## DEPARTMENT OF PLANNING AND ZONING

**DATE:** September 25, 2017

**TO:** Beauregard Urban Design Advisory Committee

**SUBJECT:** DSUP #2016-0044 – Church of the Resurrection

Attachment 3: Concept 2 Submission, Building Elevation along N. Beauregard Street

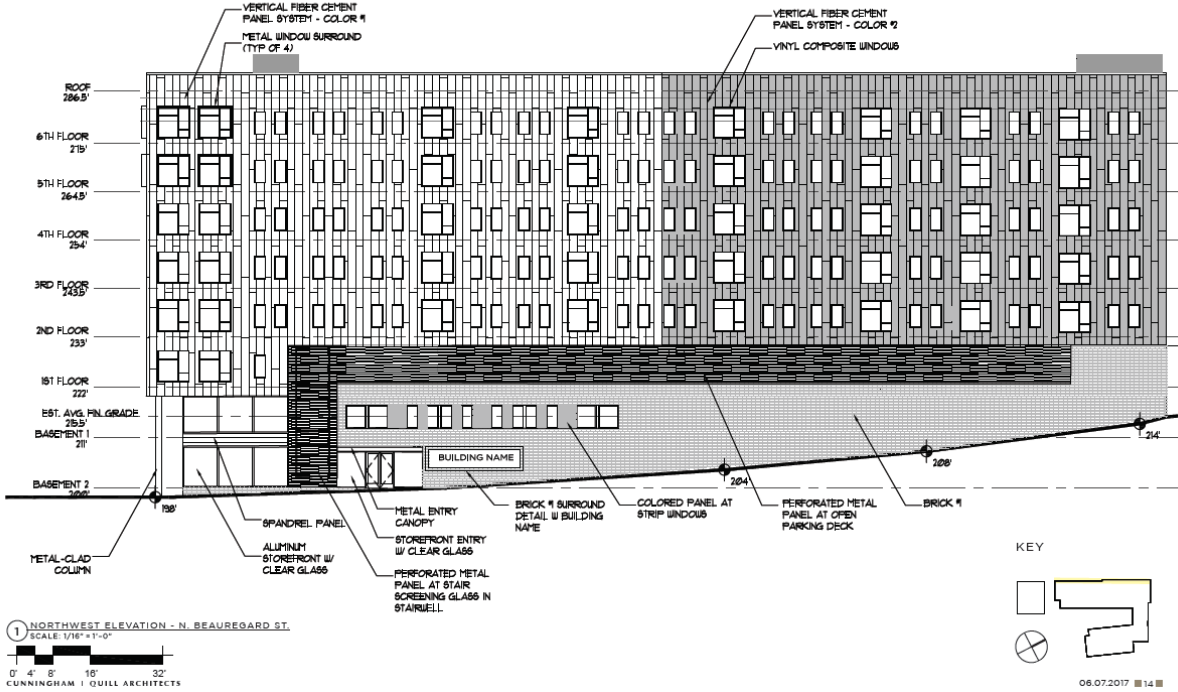
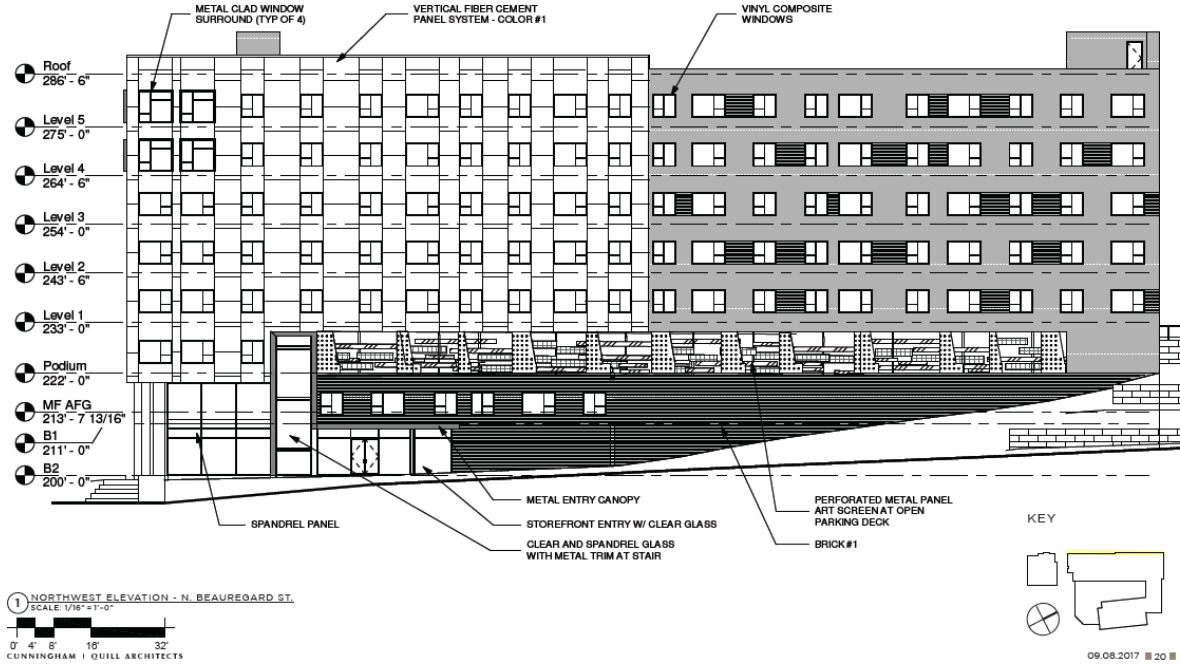
**Please see attachments 3 and 4 for a comparison of the façade refinements made by the applicant to address design comments provided by staff and BDAC between the Concept 2 submission and the Completeness Submission.**

- The window pattern has been simplified by combining pairs of smaller windows into larger windows and by aligning the heads and sills of windows to create a calmer expression throughout the building façade. The applicant maintained the asymmetrical mullion pattern which reinforces the contemporary aesthetic of the building.
- Along the N. Beauregard frontage, the applicant has utilized a consistent window pattern across both the brick- and panel-clad wings of the building to create harmony while selecting different exterior materials to enhance the expression of the building's different forms. In addition, patterning of portions of the brick between windows has been applied to create a random, staccato overlay, which gives the brick portions a more lively character.

- As requested by staff, BDAC, and Goodwin House, the applicant substantially increased the amount of brick cladding, going from a limited brick presence at the base of the structure to a full-height brick exterior on several expressions of the building frontage.
- The applicant removed the use of colored panels (limited expression along N. Beauregard Street and along Fillmore Avenue) and adopted a simple and effective color palette of grey panels and red brick with white accents.
- The use of a vertical panel was clarified by the architectural team so the panels' joint pattern enhances the existing window pattern to emphasize a vertical expression. Meanwhile, a horizontal rusticated brick pattern was utilized between select window

- With encouragement from the BDAC committee to enhance the entrance gesture at the intersection of Fillmore Avenue and N. Beauregard Street, the applicant added to the initial elemental design of a cantilevered edge supported by a singular column by adding a metal entry canopy. The additional architectural canopy enhances the building entrance and the use of a white accent color references the white column at the corner and connects the corner of the building with the now prominent building entrance.

- At the initial BDAC presentation, the southwest elevation of the building showed a lack of windows at the terminus of the building closest to the church, creating an expansive blank wall that would face the church and vehicles driving north along N. Beauregard Street. Staff and the BDAC committee requested the applicant explore the addition of windows along this wall, which has been met in the current submission. The applicant added additional windows in both the individual apartment units and within the hallway, and staff strongly supports the additional architectural refinement presented by the applicant.

Attachment 5: Northeast Elevation (as seen from Fillmore Avenue) with Suggested Staff Revisions

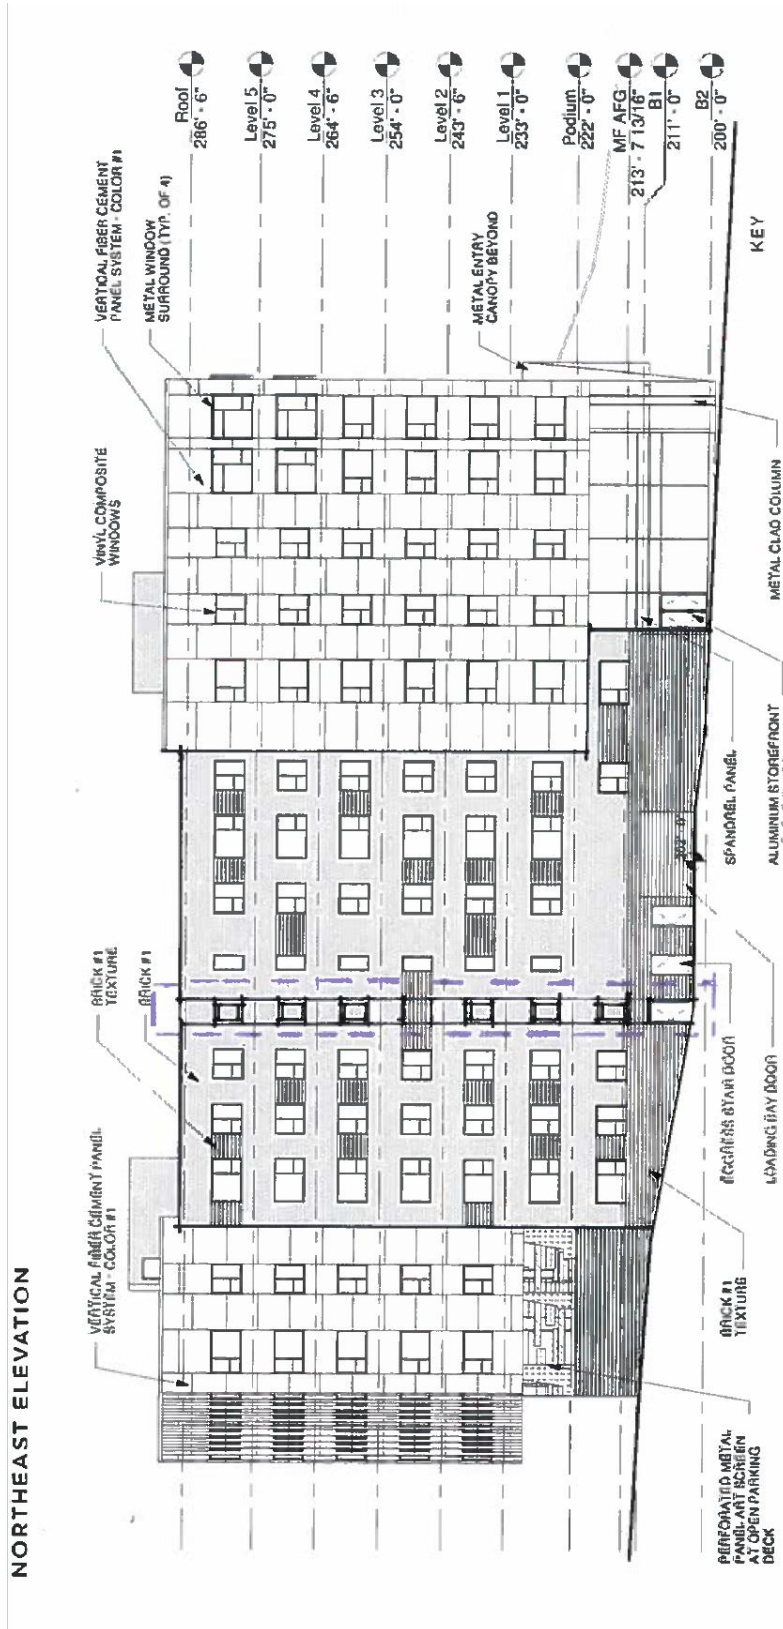
Attachment 5: Northeast Elevation (as seen from Fillmore Avenue)

- Consider introducing a shallow niche, which would run from the exterior door (in the plumbing room), at the ground floor, up the vertical side of the building, breaking the central brick mass into two asymmetrical components. Consider inserting windows in this recessed niche, or even exploring the use of gray panel in the niche to reference the adjacent paneled components.

Attachment 6: Southwest Elevation (Arm of multi-family building closest to Goodwin House)

- Similar to the addition of windows adjacent to the stair tower in the northern arm of the building, consider adding an additional niche and row of vertical windows in the stair tower of the southern arm of the multi-family building (closest to Goodwin House), to demarcate the brick/panel interface more dramatically.

Attachment 7: Proposed Landscaping along N. Beauregard Street  
*Landscaping Shown at Concept 2 Submission (Prior to addition of landscape architect on team).*

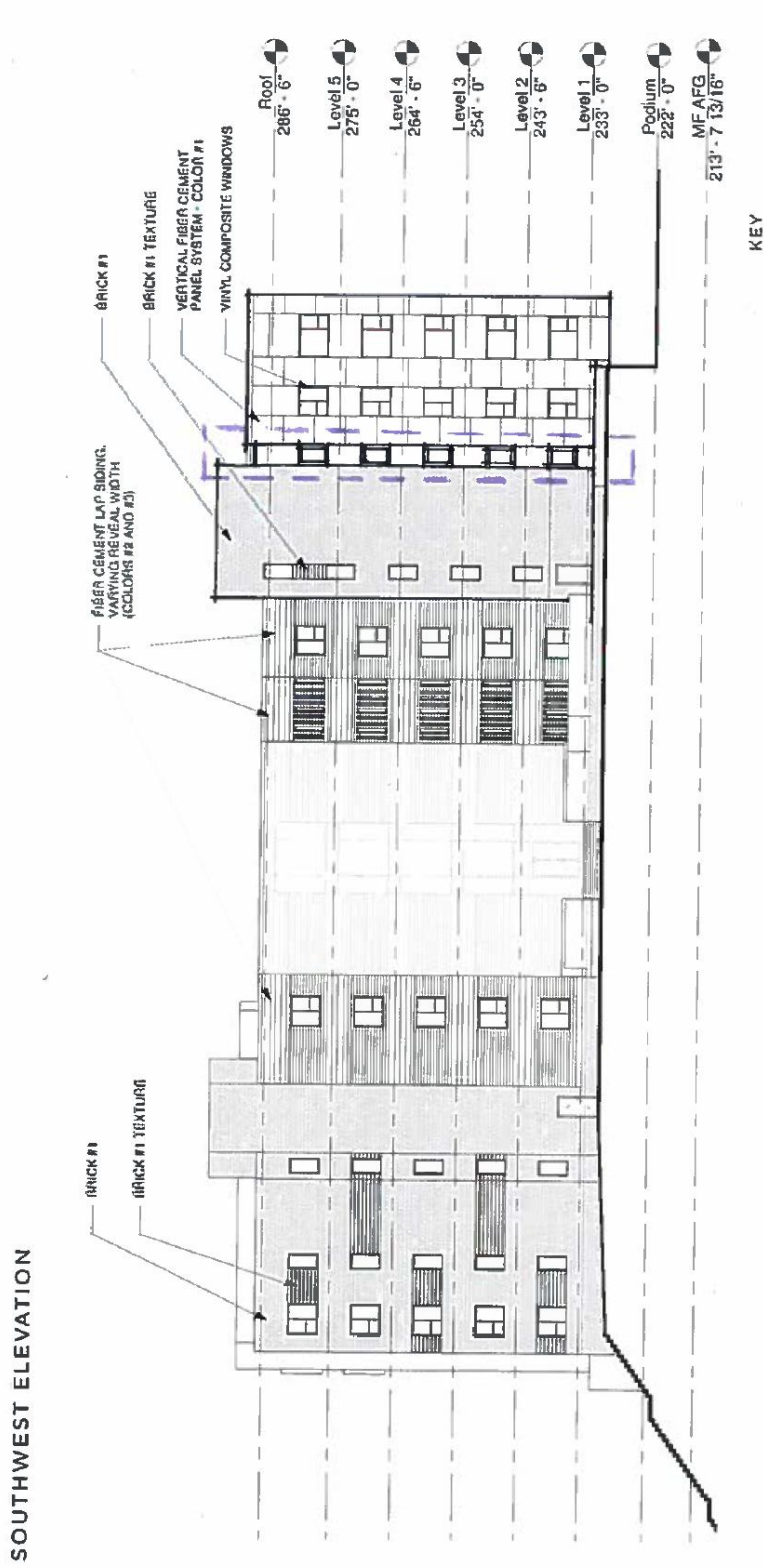
**Please see attachment 7 for a comparison of the treatment of the building frontage as it relates to N. Beauregard Street between Concept 2 and the current Completeness Submission.**

- The applicant has expanded the area of the glass lobby at the corner of the building, which increases the feeling of openness along the future sidewalk.

- The metal screening around the open parking deck has been refined from an all-over, functional mesh presence to an architectural screen with panel art to create a dynamic expression around three sides of the structure. Staff finds the open mesh and artistic design help emphasize the desired architectural effect of defining a grounded base of the building (brick) and floating building elements above. The design improvements enhance the overall lighter feel of the building's presence which has been achieved through many of the design refinements.

- The landscaping design proposes a series of terraces which gently grade the existing hill in front of the proposed multi-family building and reduce the presence of the large brick wall. Additional plantings along the terrace will further reduce the perceived massing of the multi-family building and enhance the pedestrian experience. Staff supports the architecturally dramatic stairway which provides pedestrian access from N. Beauregard Street to the upper courtyard that connects the church and multi-family building. The arc of the stairwell mirrors the projection of the terraces and creates a welcoming connection from the street.

- Consider extending the terraces even further north along N. Beauregard Street in front of the multi-family building to further enhance the overall landscaped design and screen more of the heavy building base.
- Consider adding a stairwell runnel along the straight edge of the stairway to enable bicyclists to ascend and descend the stairway.
